Change of Levels of 12no Houses Approved Under Planning Permission 16/00362/FULL

Ward Lochee
Address
 44 Gray Street, Dundee

Report by: Head of Planning
 & Economic Development

Figure 1: Proposed Site Plan

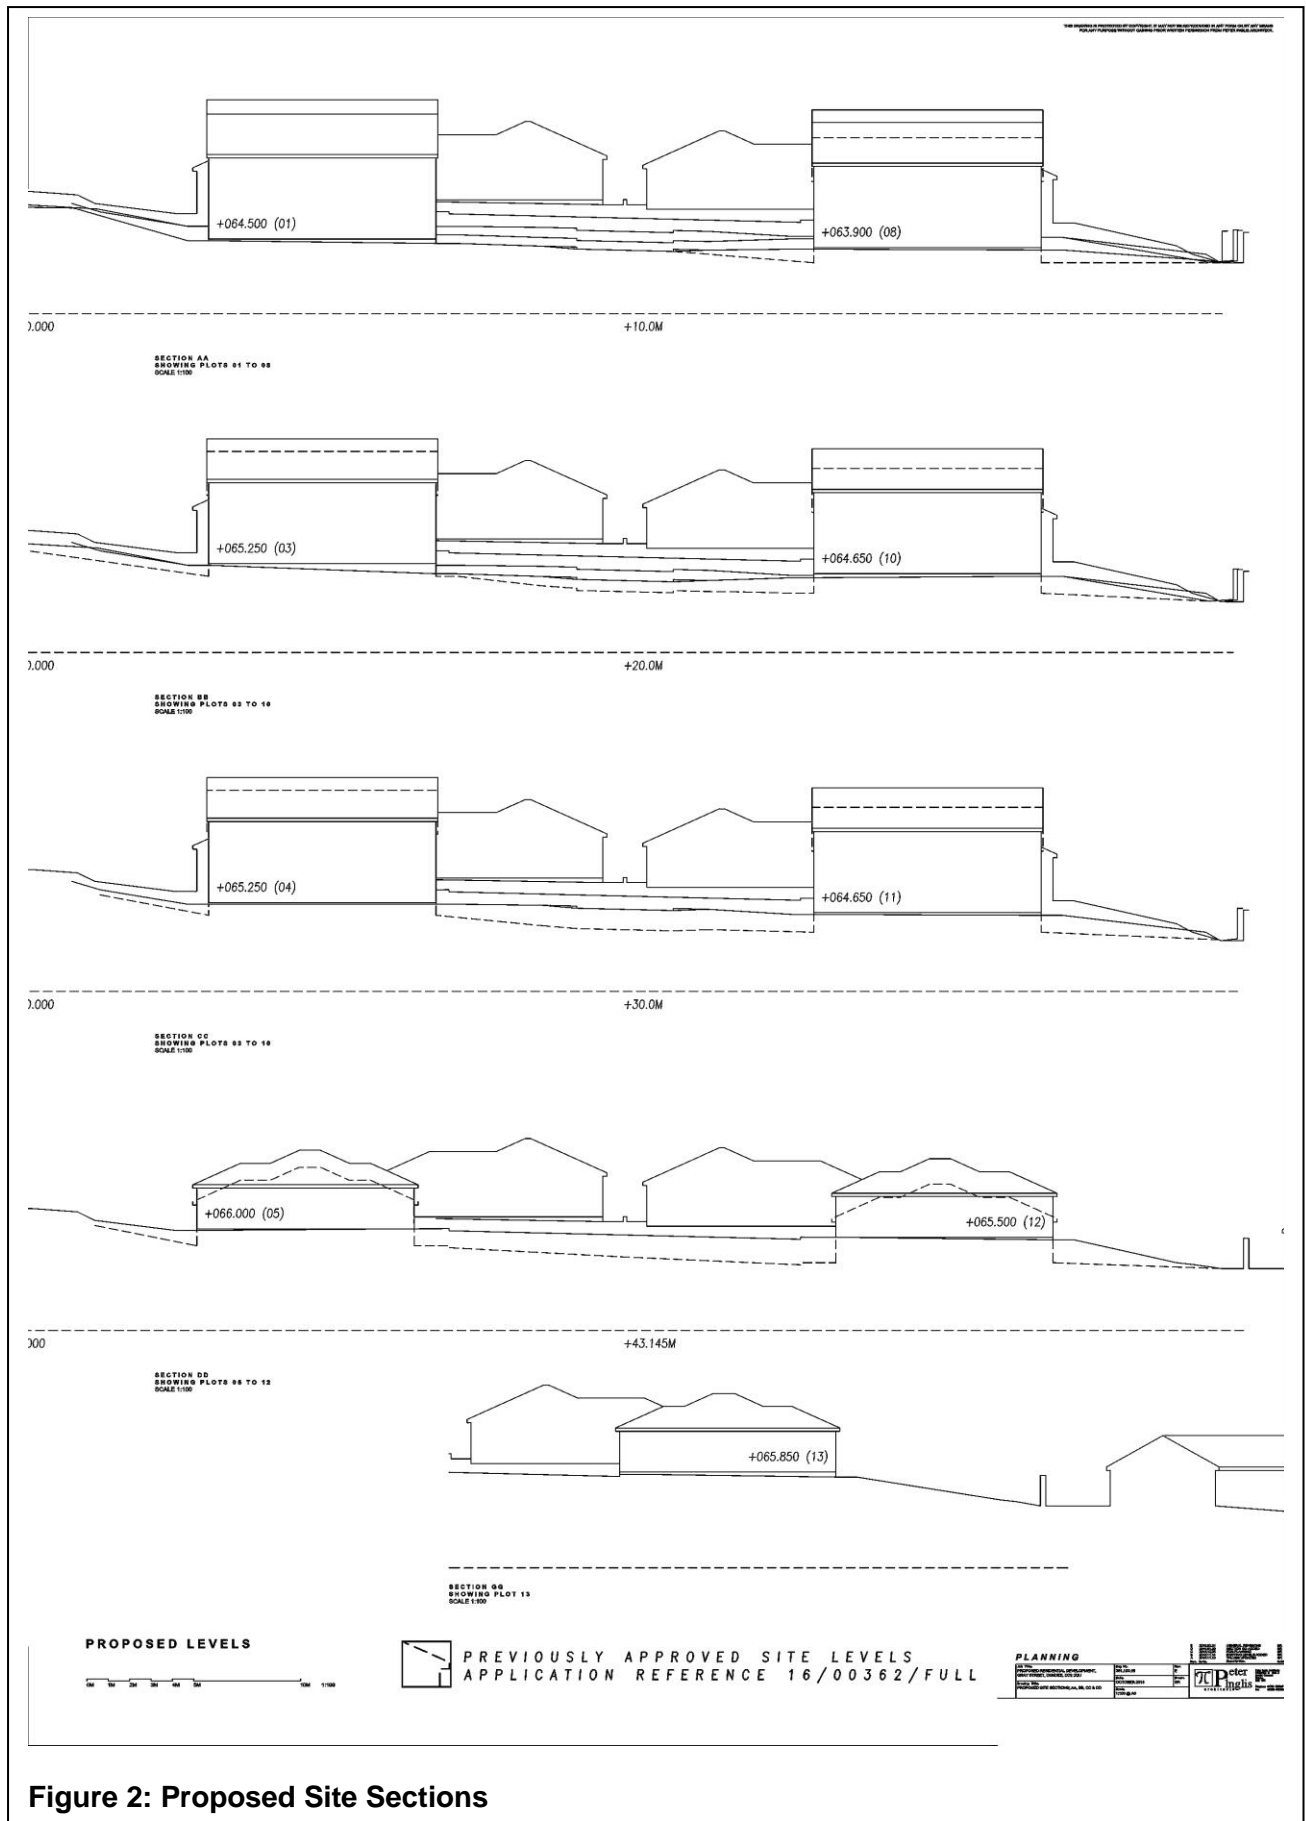
- 7.5 This application proposes changing the approved levels on 12 of the 14 plots. The submitted site plan shows that proposed floor levels vary between 750mm and 1,700mm across the site with the highest increase on Plot 6 (1,350mm); plot 7 (1,700mm); Plot 12 (1,500mm); and plot 13 (1,350mm).

- 7.30 **Cycle Provision** - the proposed site plan shows a covered bicycle store in the curtilage of each house in line with the standard.
- 7.31 **Amenity/Garden Ground** - the proposed site plan indicates that rear garden areas of 105m² to 195m² would be provided in line with the standard. However, the garden areas adjacent to the north boundary and the south boundary of the site would be on a slope. Also due to the different levels across the site and the layout of the houses the gardens on the eastern section of the site would be overlooked. Although meeting the size requirements set out in this standard, the standard is not met in respect of the usability and amenity of the proposed garden ground.

Figure 2: Proposed Site Sections

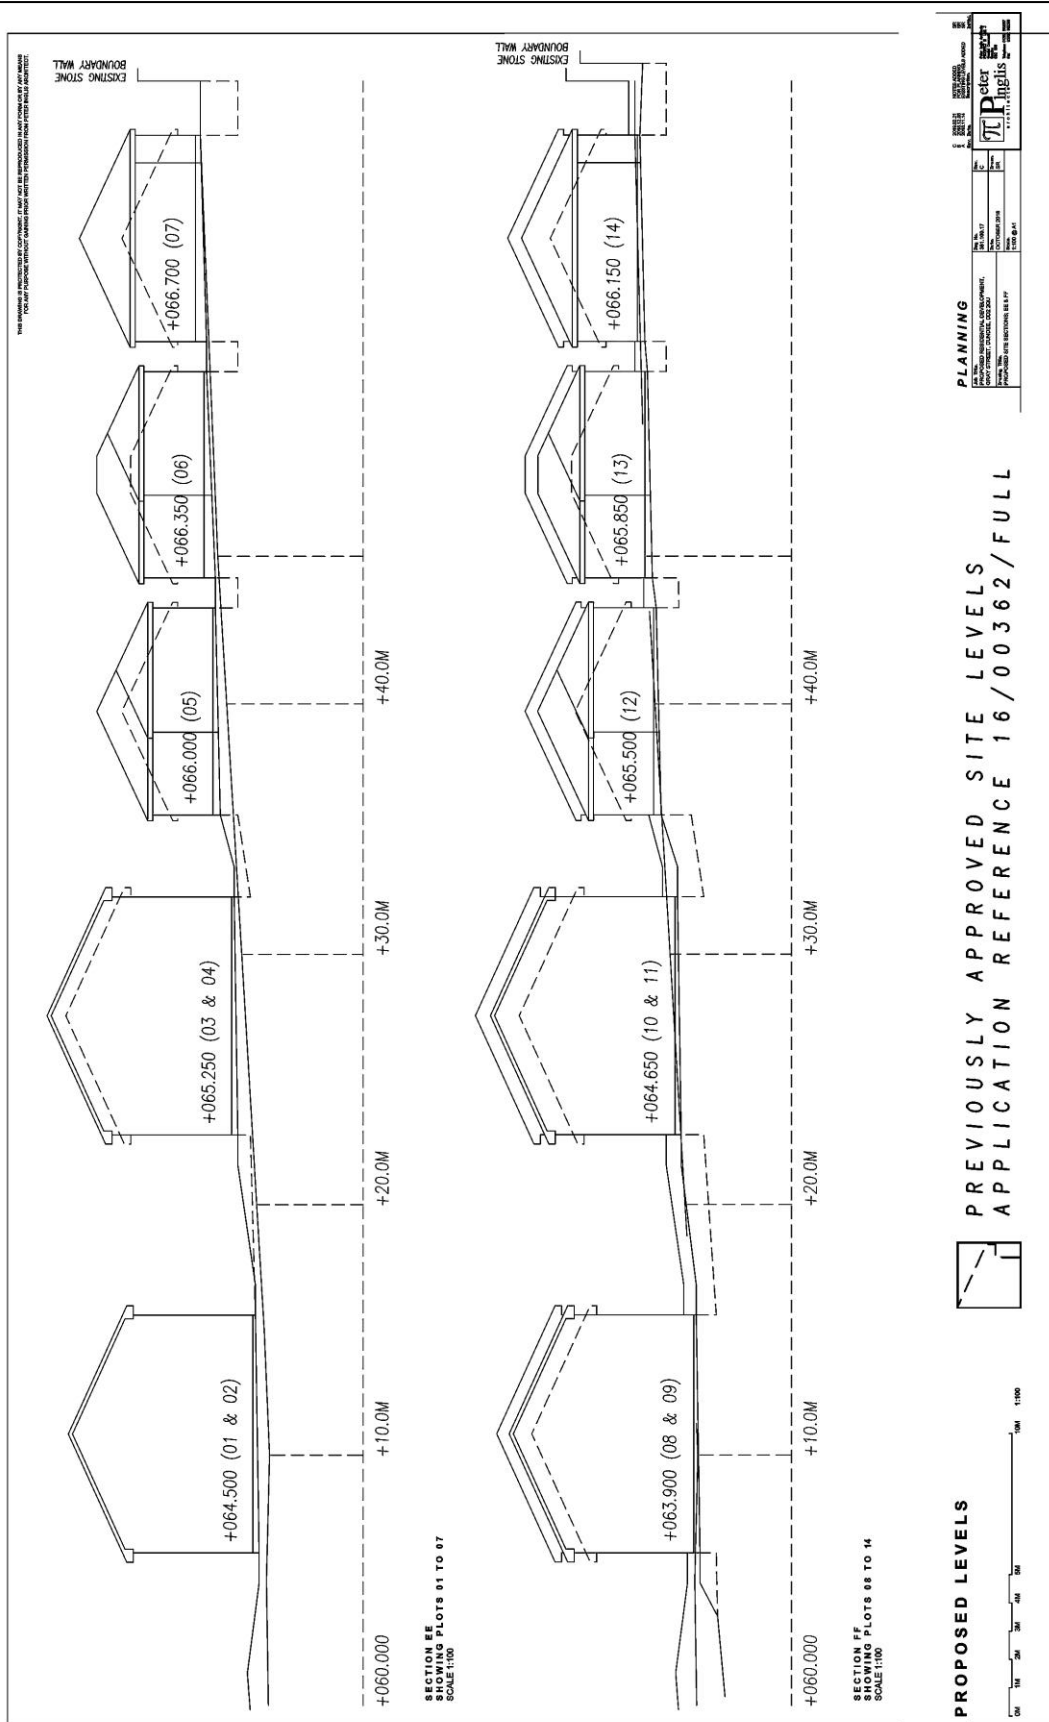
- 7.53 The proposed level changes to the plots on the southern boundary are 900mm for Plots 8 and 9; 1,150mm for Plots 10 and 11; 1,500mm for plot 12 and 1,350mm for Plot 13. The site sections show the result of this level change whereby the rear garden ground will slope down to the proposed brick boundary wall which will impact the usability of the garden ground for the proposed homes.

Figure 5: Site Photo – Existing Property South East of Application Site

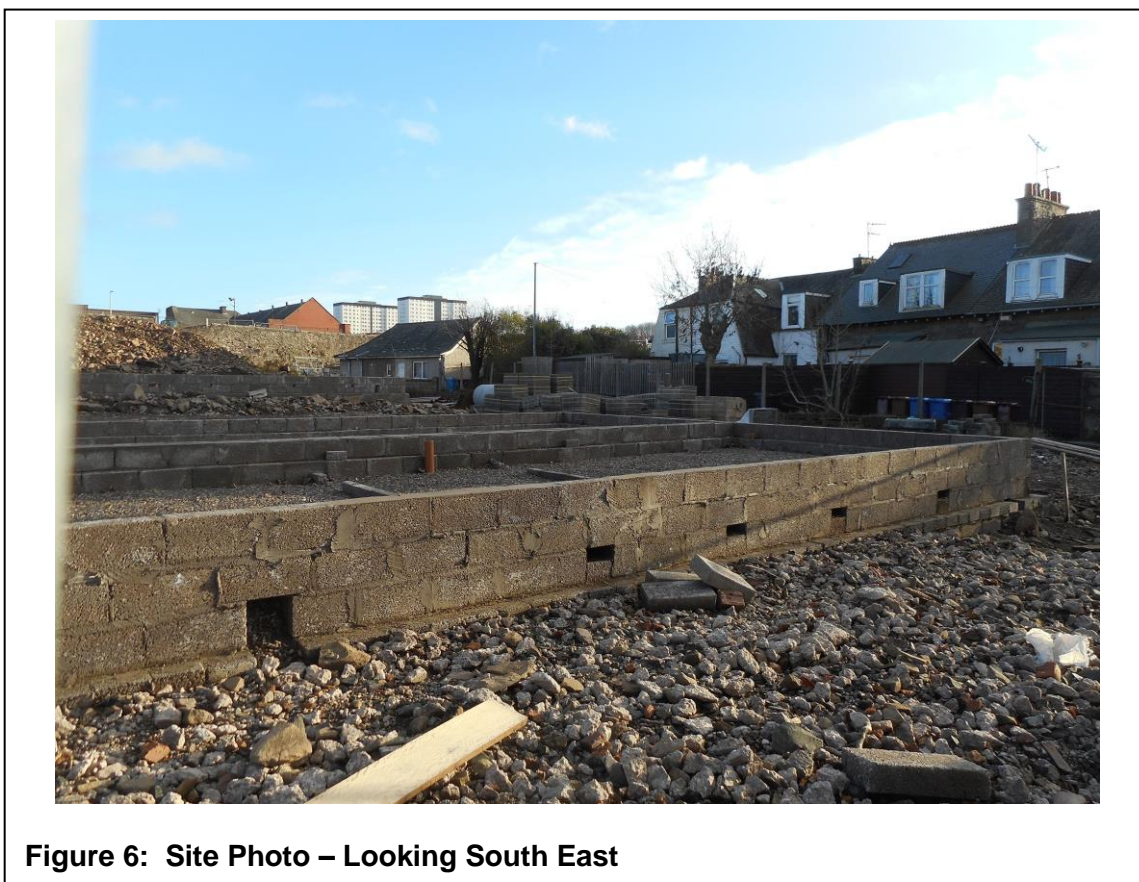
- 7.11 Further, plot 12 (proposed floor level rise 1,500mm) and Plot 13 (proposed floor level rise 1,350mm) are to be situated 14m and 15m respectively from an existing single storey house located at 48 Gray Street, to the south-east of the site. As such the facing windows of habitable rooms are less than 18 metres. The proposed new houses will sit above 48 Gray Street resulting in an over bearing development further exacerbated by the proposed brick wall (1,800mm) being positioned 3 metres from the front elevation of the existing house (see Figure 5).
